**Subject: Enterprise Recycling & Disposal Facility
Angelo's Aggregate Materials, Ltd.
FDEP Permit Nos. 177982-001-SC, 177982-002-SO
Pasco County, Florida**

On behalf of Angelo's Aggregate Materials, Ltd. (Angelo's), Hartman & Associates, Inc. (HAI) is submitting this plan for continuing excavation of Cell 1 at the Enterprise Recycling & Disposal Facility in accordance with Specific Condition #5 of the above construction permit. Limestone was encountered at two locations in Cell 1 at an elevation of approximately 90 feet, NGVD, 9 feet above the approved base elevation for that cell. These two locations are approximately 15 feet x 20 feet and 20 feet x 20 feet in size, see the attached photos and approximate site plan locations. The limestone encountered was brittle to well-indurated, massive, fossiliferous limestone with traces of dissolution features. Excavation has ceased in these areas until the Department provides further guidance.

Re: Enterprise Recycling & Disposal Facility

Limestone Encountered

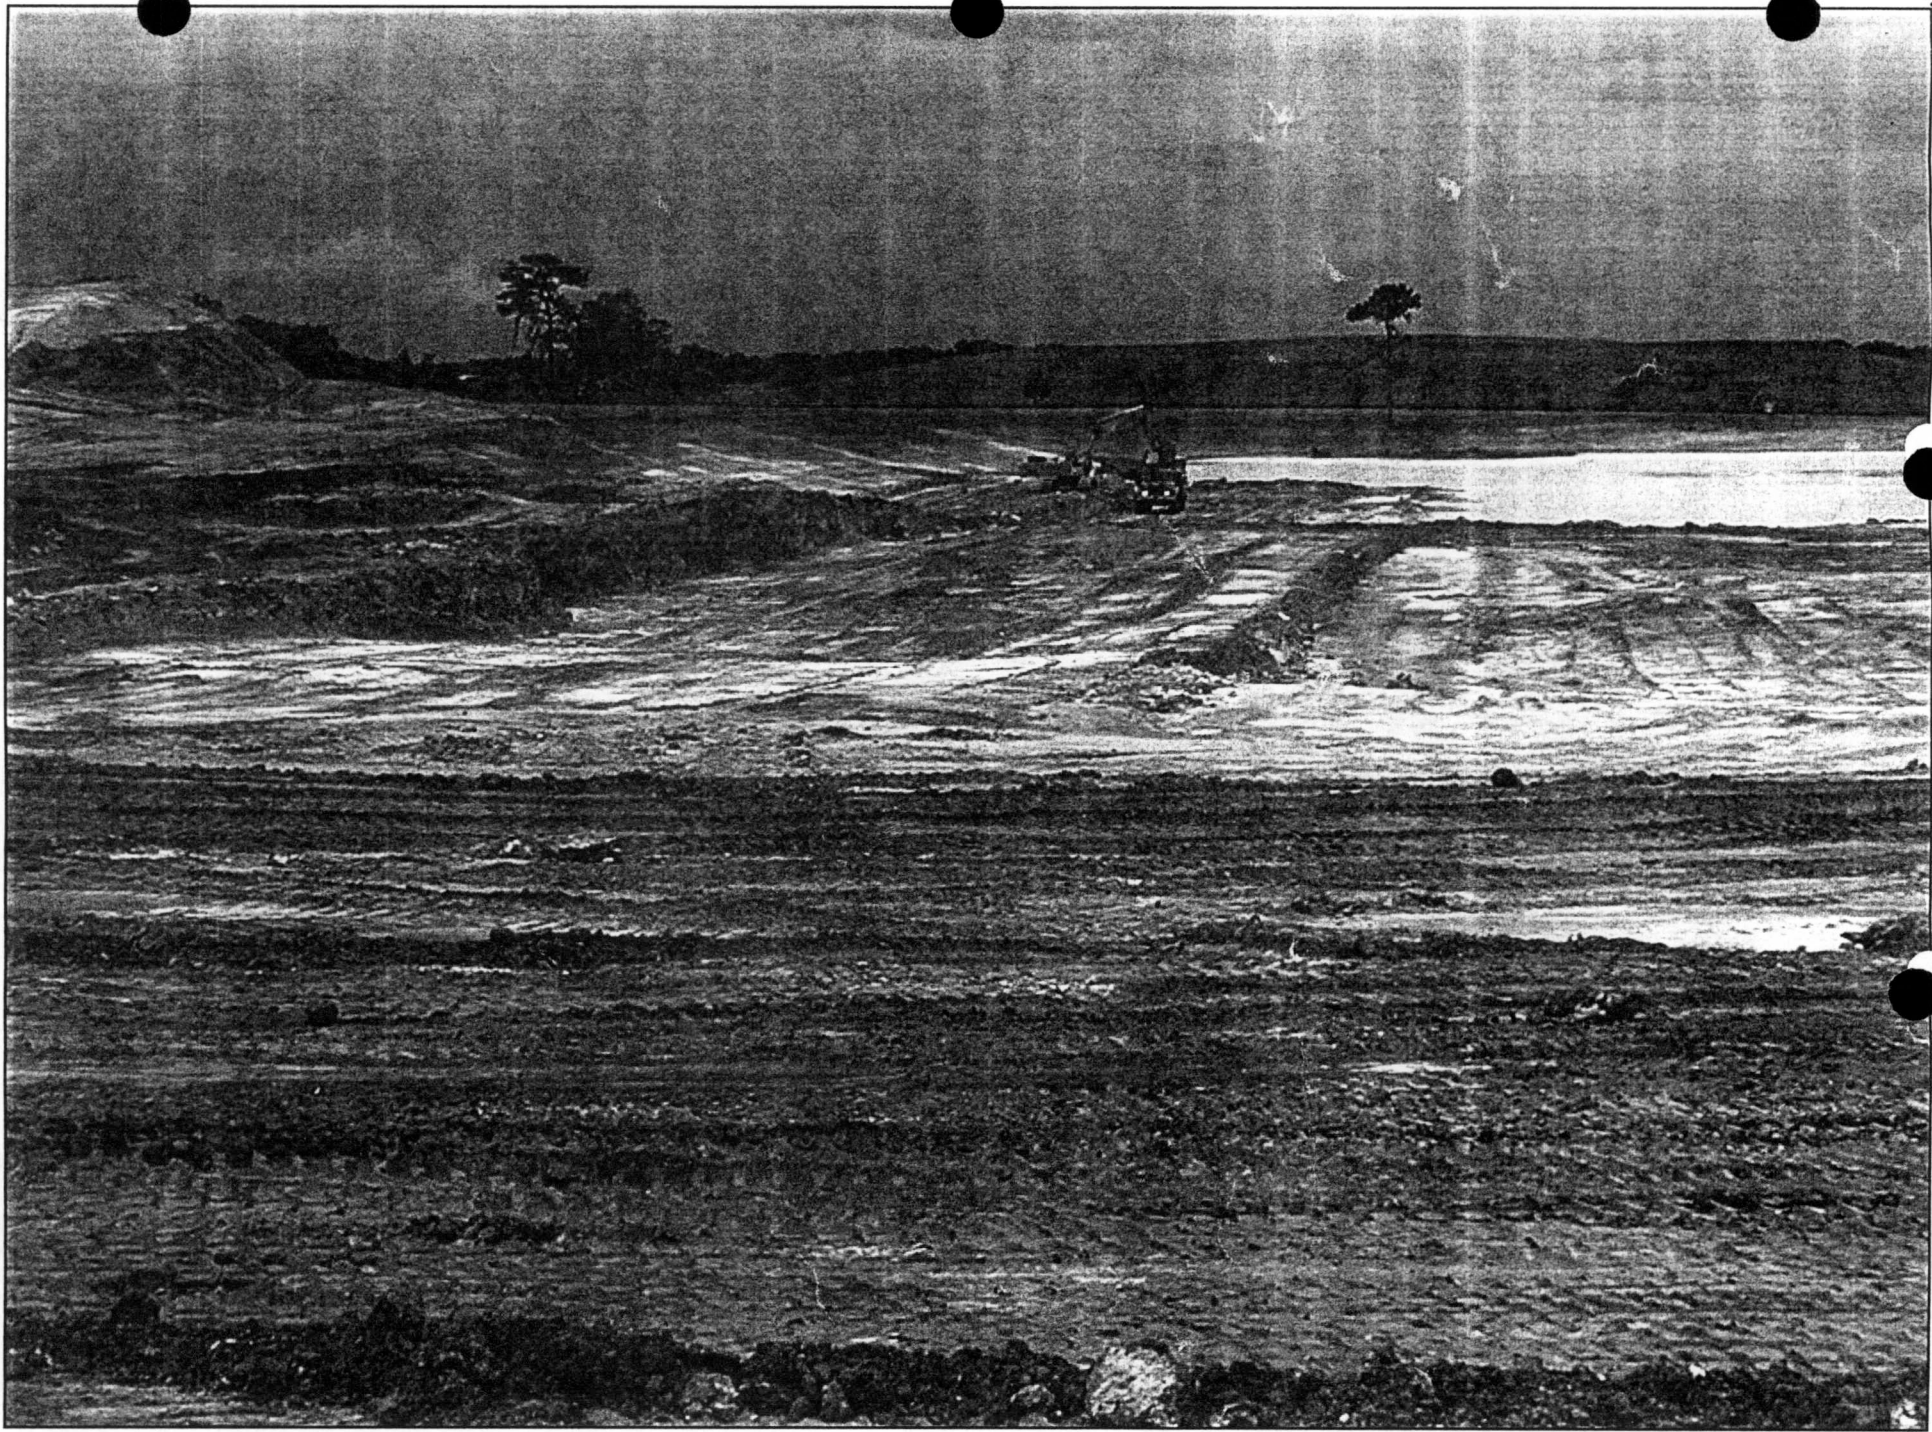
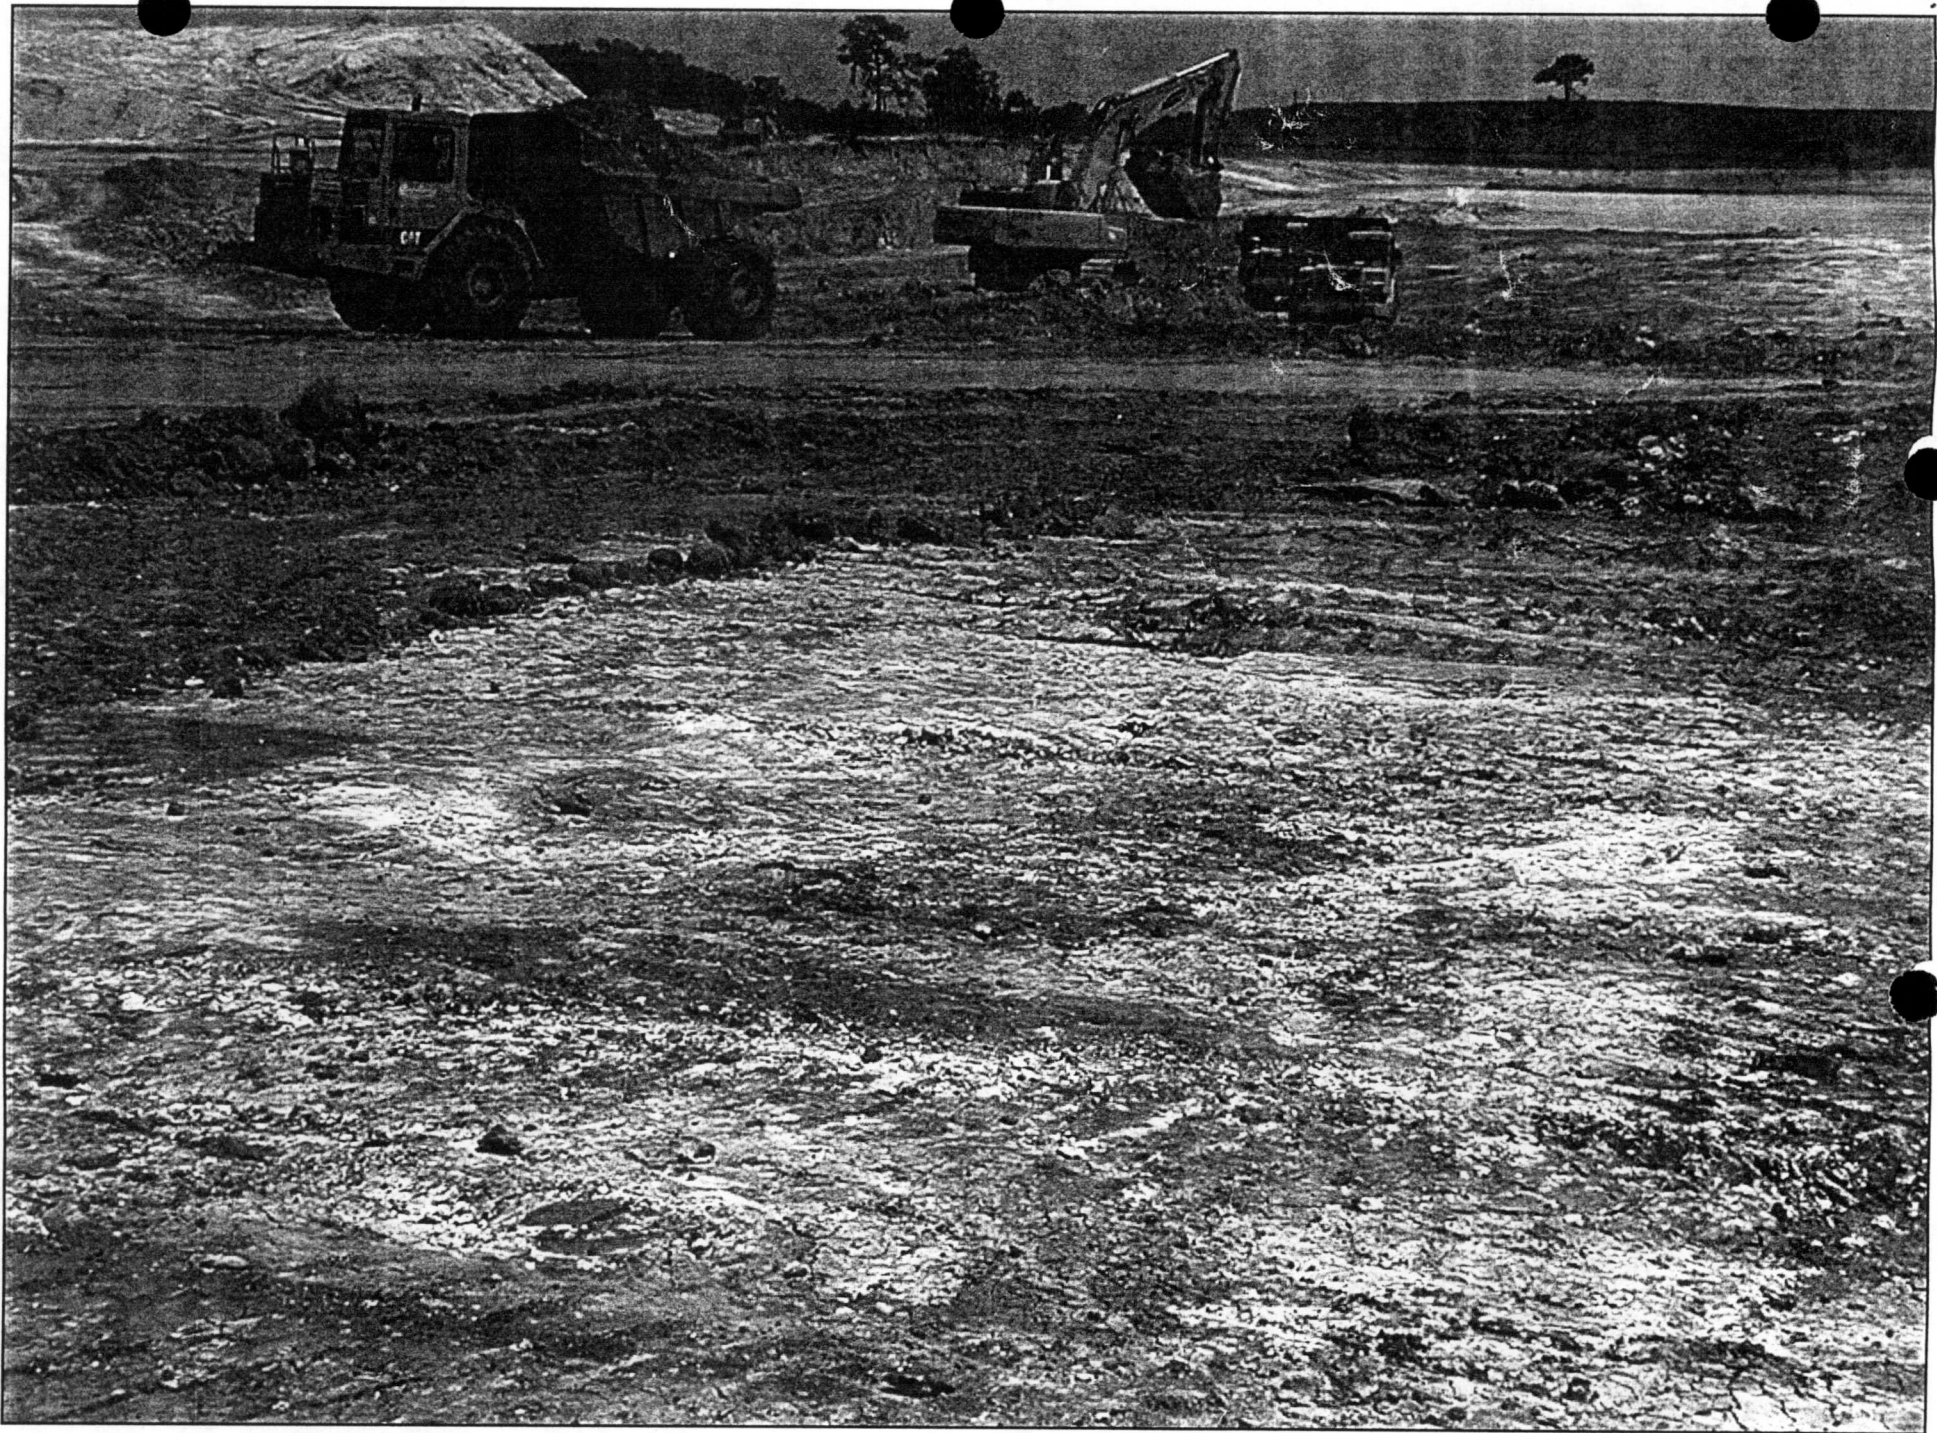
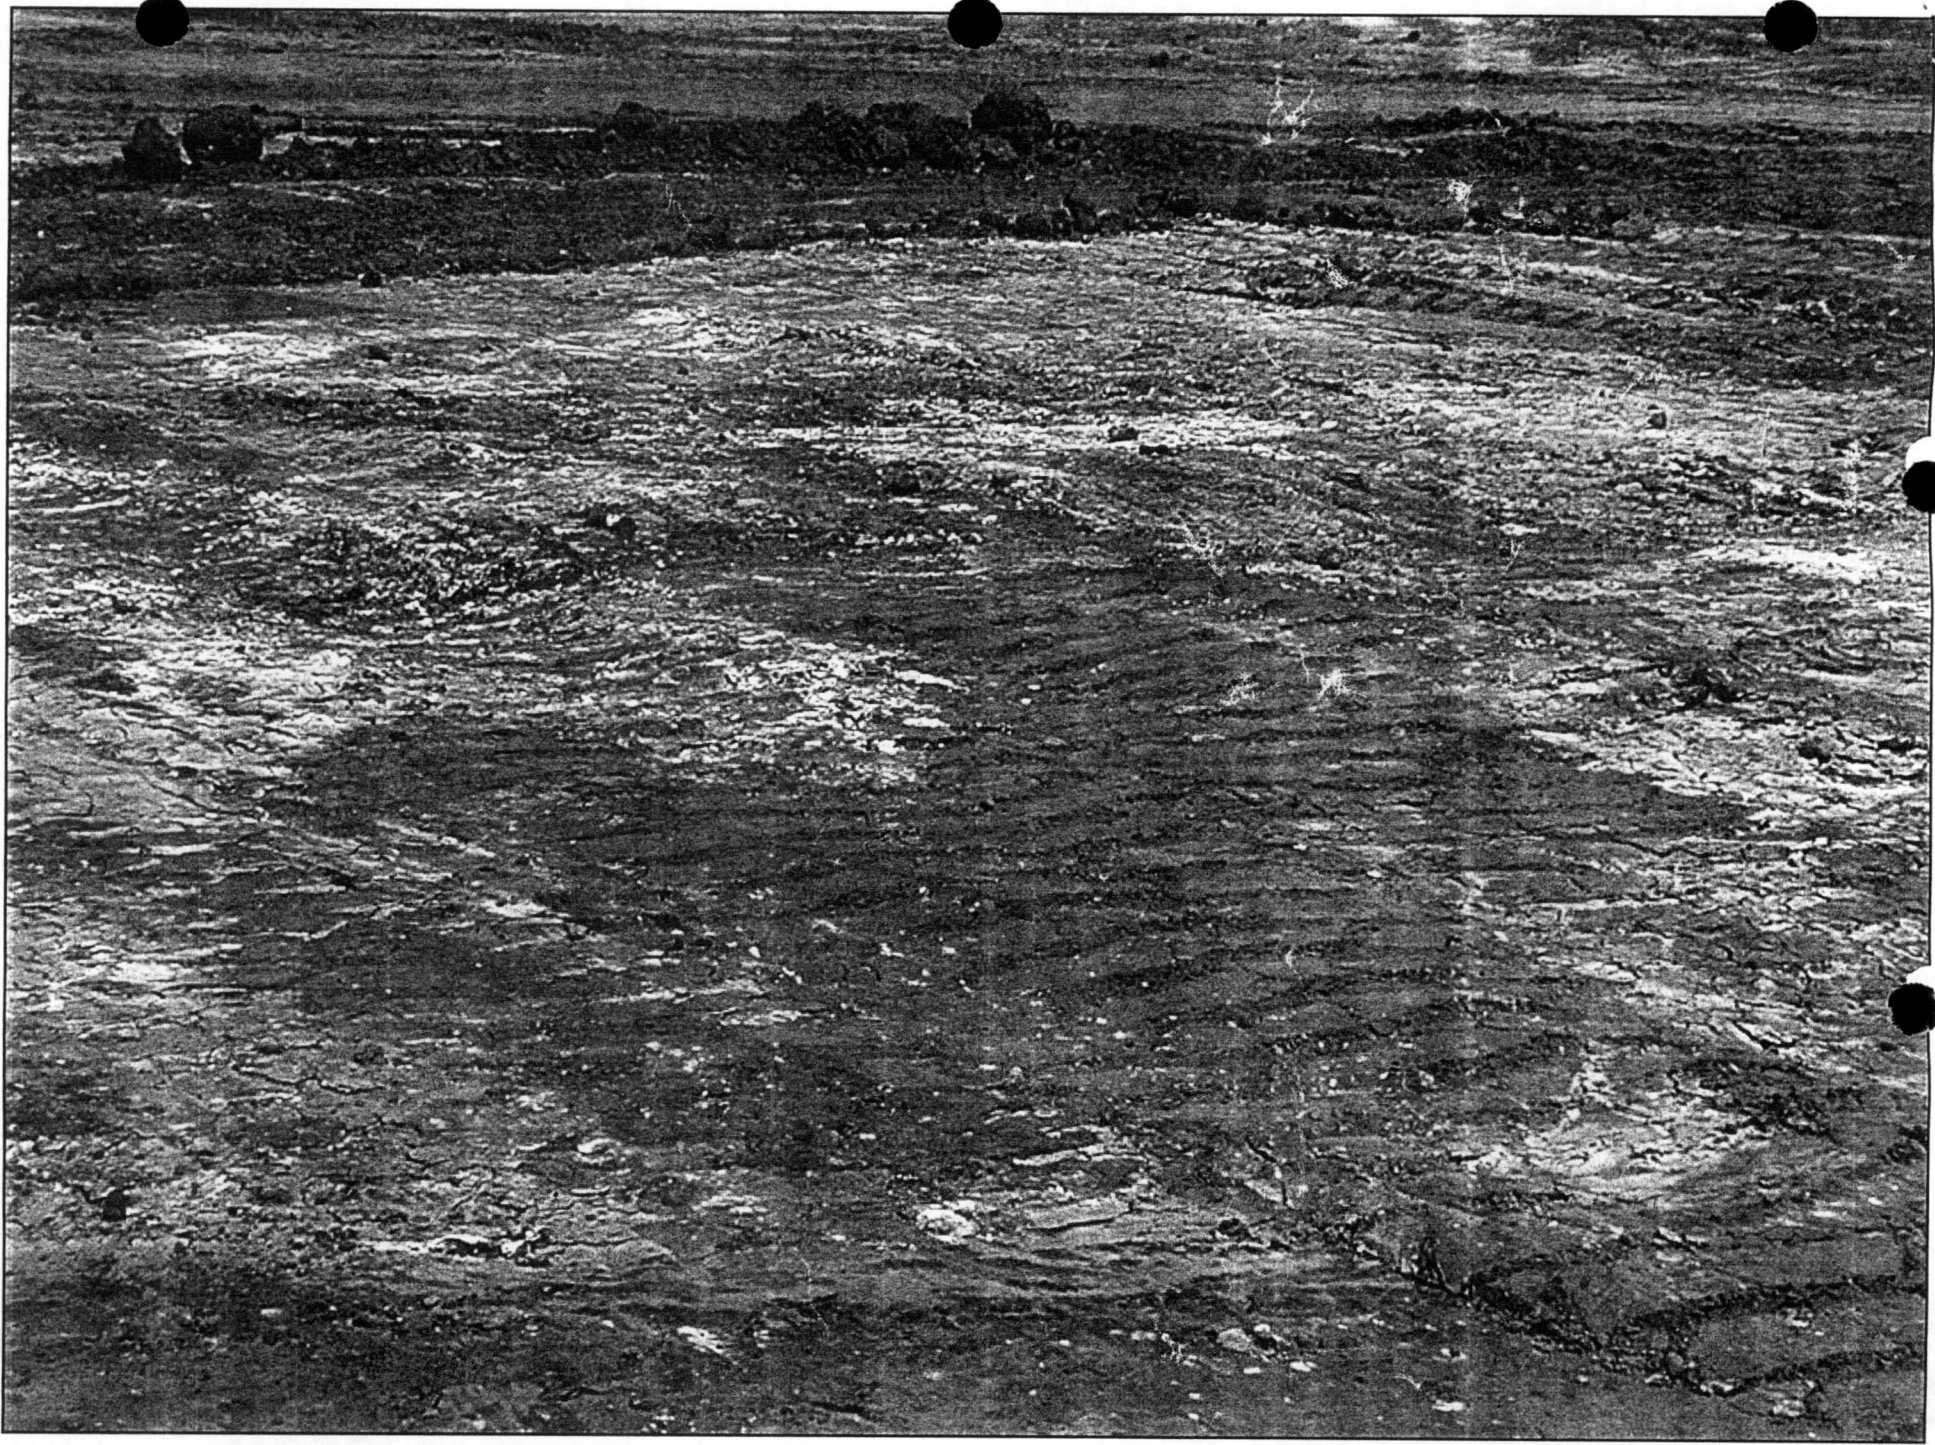
HAI is proposing to continue excavation in Cell 1 to the approved base grades (80-82 feet, NGVD). At completion, any areas with exposed limestone would be over-excavated by 3-feet and patched with 3-feet of compacted clay material with a maximum permeability of $1 \times 10E-6$ cm/s, in accordance with Specific Condition #9.c of the construction permit. The clay will be tied-in to the surrounding confining layer in a step-type method. Three "steps", each 12-inches in height and 5-feet in width will be excavated in the sandy clay surrounding the limestone areas. The excavation and steps will be filled with on-site clay above the level of the surrounding base grade. A manually operated drum roller, tamper, or similar equipment, will be used to compact

Base grades of Cell 1 will be sloped away from the limestone to avoid excessive surface water infiltration into the limestone areas prior to confining layer construction. The locations and sizes of these areas will be surveyed, tied to benchmarks, and shown on the Site Plan. Quality assurance testing, as specified in the Engineering Report, will be conducted in each of these locations (one in the center and one over each side of the tie-in areas) in addition to the minimum number of tests required per cell. On-site clay is currently being tested to ensure the permeability requirement will be met in the patched areas.

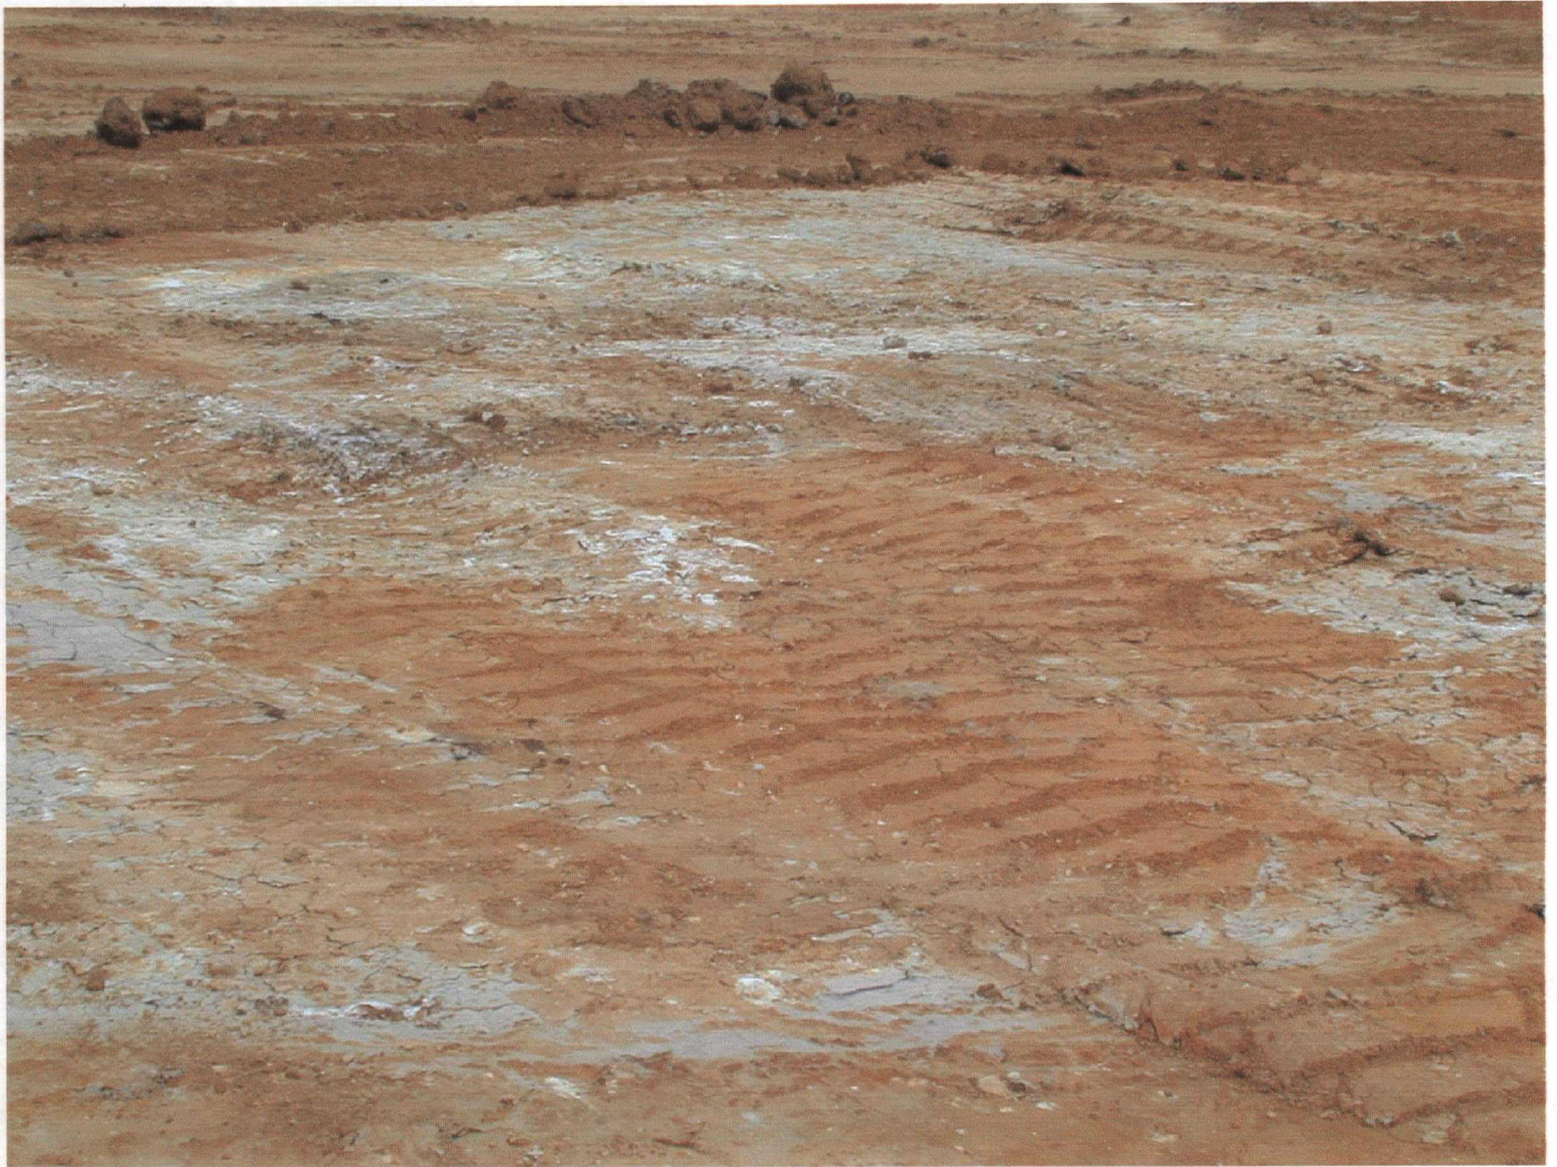
As requested, I am attaching several photos of the excavation of Cell 1 showing where limestone was encountered. We will be submitting a plan for continuing excavation for your review within the next few days. Please call Jim, Miguel or me if you have any questions.
